Minor Change Application

# Sunset Pump Station – Minor Change Application

Prepared for: Urban Utilities  
6 February 2026

Figure 1: Design reference for parking bollards.

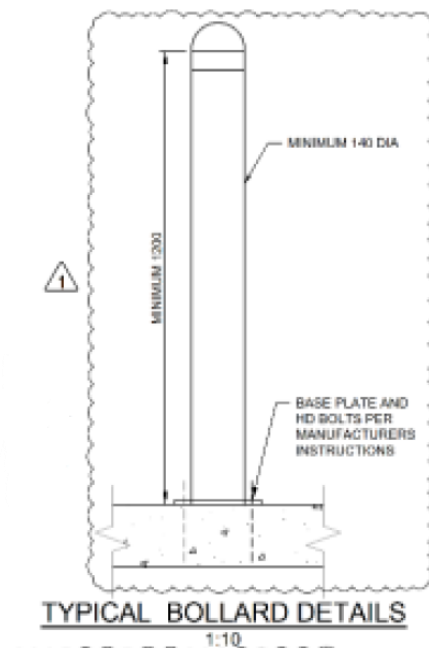
The approved plans currently provide no specific measures to prevent vehicle impacts to the main SPS infrastructure beyond the existing security fence. To address this gap, designers have identified the need for parking bollards to reduce the risk of accidental vehicle damage during chemical deliveries. It is proposed to install six bollards, each 1.2 metres in height, at 1.4 metre spacing along the eastern side of the approved chemical delivery bund. Parking bollards are a standard vehicle restriction technique widely used across utility and industrial sites. The proposed bollards are minor in scale, do not alter the approved assessment benchmarks, and have no impact on the intent or operation of the land use. Their purpose is to protect the SPS infrastructure from accidental vehicle strikes and to safeguard drivers by minimising potential damage to reversing vehicles.

This addition is considered an inconsequential modification that enhances safety without changing the approved development outcomes. Importantly, Brisbane City Council has indicatively consented to the type of bollards proposed, as detailed in *Delivery Bund and Storage and Dosing Unit Slabs Details Rev 0 (15/11/2024)*. This confirmation further supports the suitability of the modification and ensures alignment with council expectations. Figure 2-1 identifies the typical bollard design intended.

Figure 3: Amended Landscape Plan No. 2

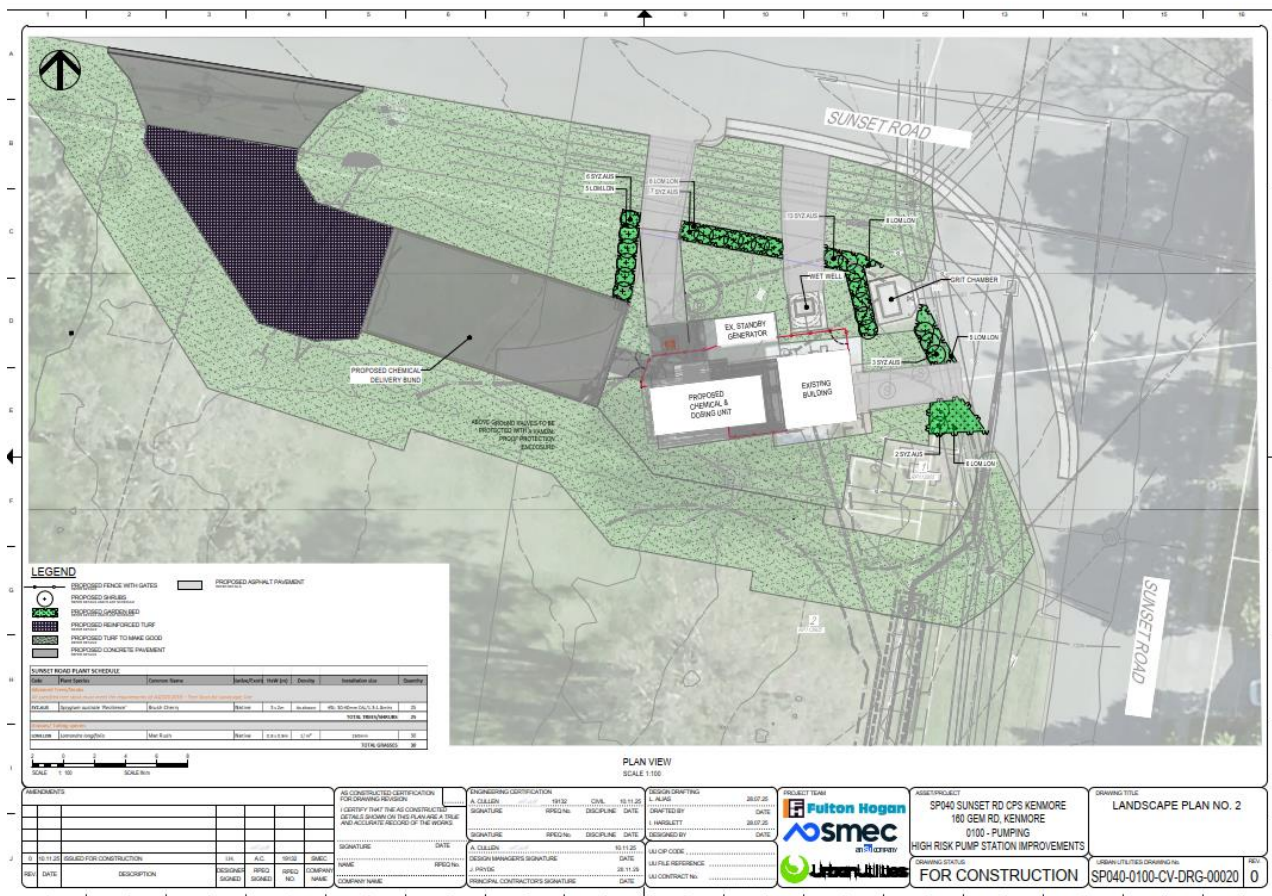
As part of the general “in accordance” submission, an updated package was lodged on 15 February 2024 to address vehicle rollover safety requirements. This submission proposes the repositioning of the Chemical Bund Deep Sump from the north-west corner to the south-east corner of the layout. The adjustment does not alter the dimensions of the bund or any other development elements, aside from the reconfiguration of connecting pipes. In the revised layout, the sump is positioned behind the proposed bollards, providing additional protection against accidental vehicle impacts, refer to Figure 1 above. The modification has been presented as minor in nature, with no anticipated effect on assessment benchmarks, land use intent, or operational outcomes.

In addition to the sump relocation, the submission also includes reconfiguration of connecting services. These comprise a proposed underground ferrous chloride line, an above-ground electrical power supply, an above-ground potable water line, and an underground electrical communications line. These service

Figure 4: Amended Civil General Arrangement design for odour control.

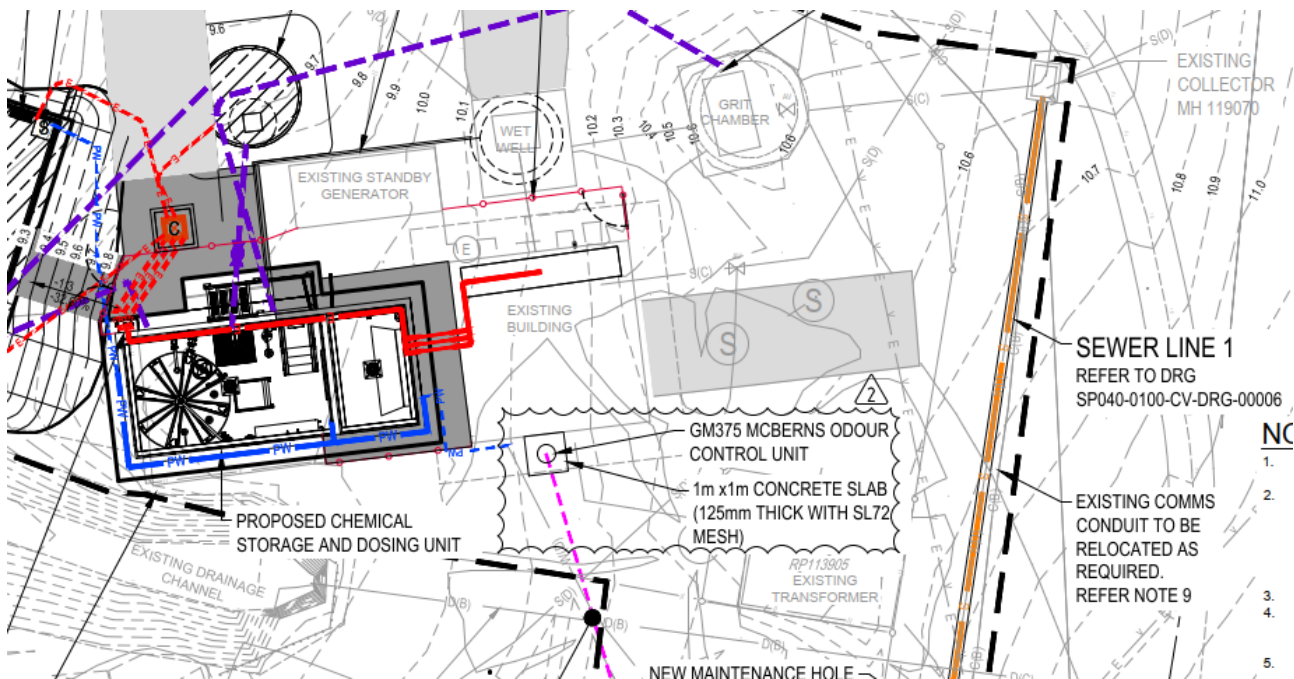
During inspection of the existing vent pole at the pump station, it was determined that the pole functions solely as an air intake and provides no odour control. Consequently, it cannot be repurposed for odour management. To address this issue, the installation of a McBerns charcoal-based odour control unit has been proposed. The GM375 unit employs activated charcoal to capture and neutralise odours, with filters requiring periodic replacement to ensure ongoing effectiveness. The project design, identified by a red box in Figure 2-4, includes the addition of a GM375 McBerns Odour Control Unit mounted on a 1 m by 1 m concrete slab, 125 mm thick and reinforced with SL72 mesh. By neutralising hydrogen sulphide (H<sub>2</sub>S) emissions from the SPS, the GM375 is expected to significantly improve amenity, enhance local air quality, and reduce odour impacts on nearby communities.

To support the project development, odour modelling was conducted to confirm the potential impact on residents to the east of the site. Specifically, the modelling demonstrated that no detectable odour is present at a distance of 5 metres from the unit. This confirmation ensures that the installation achieves its intended environmental outcomes and complies with amenity expectations for the surrounding community. Please find attached the updated Odour Assessment Report in Appendix C

Figure 5: Amended Civil General Arrangement design for security fencing

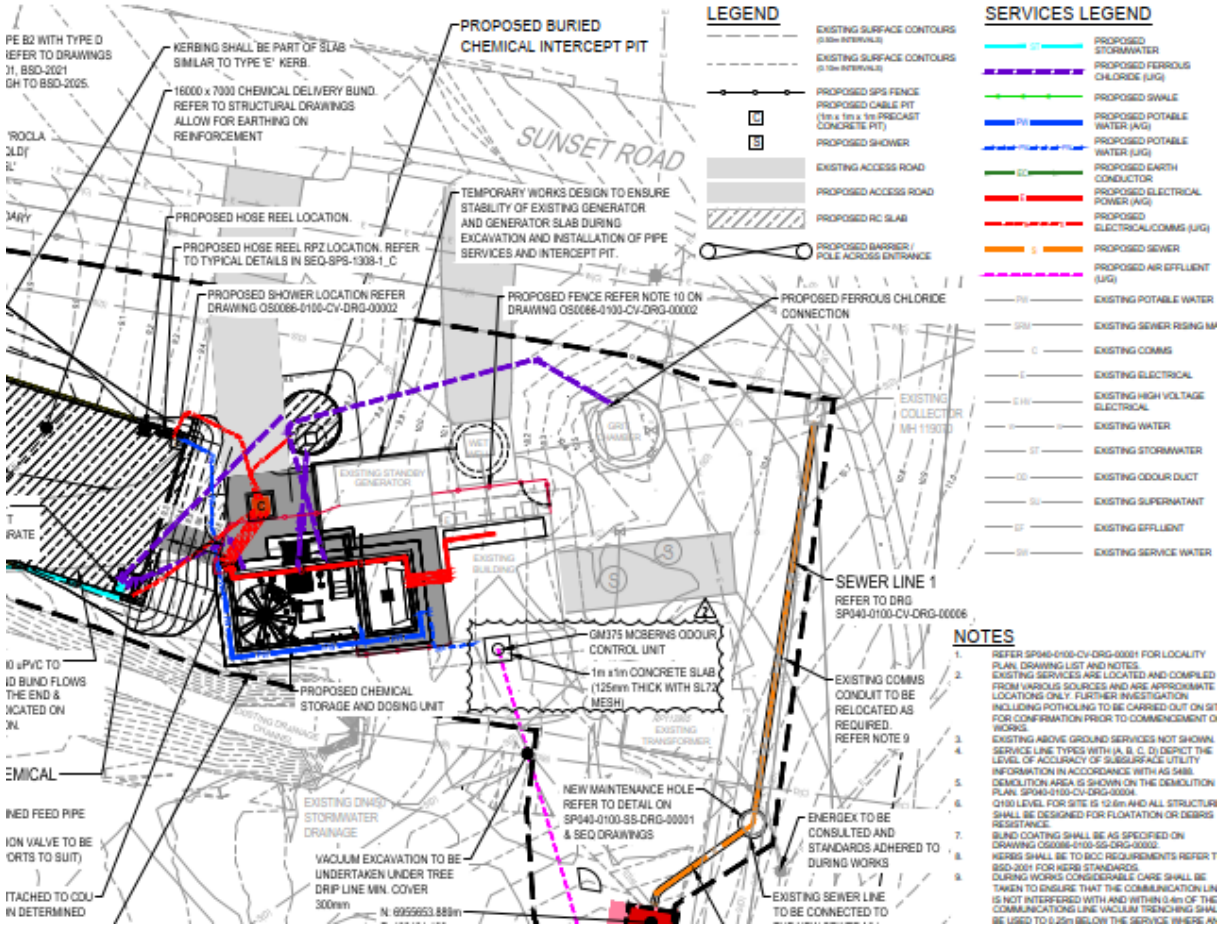
The fencing will enclose the pump station and be constructed in accordance with UU standards. In response to council requirements, barbed wire will not be used. Instead, the fencing will consist of black steel powder-coated spike panels, providing a secure and visually acceptable solution. Figure 2-5 identifies these changes outlined in the red box.

The location of the fencing has been modified to avoid interference with operational activities. Rather than fully surrounding the facility, the fencing will attach directly to the building at selected points, ensuring both protection and functionality. In addition, barbed wire will be installed above the generator to provide enhanced protection. The fencing will require custom fabrication by the manufacturer, with the sliding section facing the generator designed to be removable. This feature maintains flexibility and facilitates the future relocation of the generator if required, while aligning with council expectations and operational needs.

Figure 6: Amended Civil General Arrangement design for stormwater drainage.

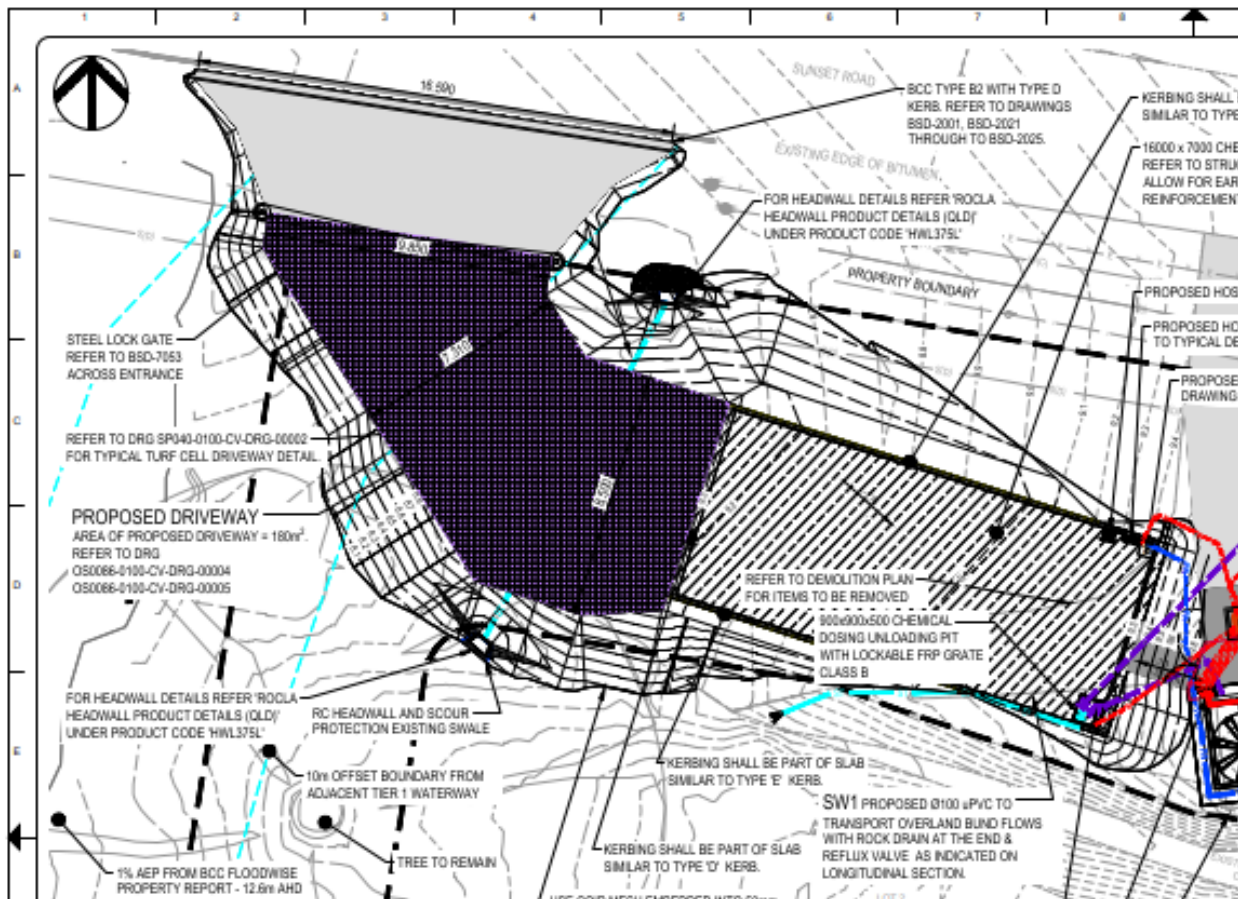
The proposal includes the installation of a chemical dosing unloading pit measuring 900 × 900 × 500 mm. This pit will be fitted with a lockable FRP grate (Class B), providing a secure facility for chemical transfer. Its design assists with stormwater management by containing and directing potential runoff within the bund boundary, thereby improving both safety and environmental protection. To further safeguard against contamination, a valve will be installed to allow operators to turn flows on and off, preventing any chemical runoff from the pump station, and entering the stormwater system. In addition to the pit, SW1 Ø100 uPVC pipework will be installed to transport overland bund flows. This pipework will terminate in a rock drain fitted with a reflux valve, as shown on the longitudinal section. The configuration ensures controlled discharge, prevents backflow, and enhances environmental outcomes by safely dispersing stormwater away from critical infrastructure. A new maintenance hole will also be constructed for sewer lines 1 and 2. This addition will facilitate easier access for inspection and servicing, supporting long-term operational reliability of the drainage network and ensuring compliance with ongoing maintenance requirements. These changes are identified in red boxes in Figure 2-6.

Additionally, the proposal maintains two stormwater release points, with no change to the existing amount. These release points are integrated with the existing road drainage system, and their improvement will enhance flow efficiency and environmental protection without altering the overall discharge volume.
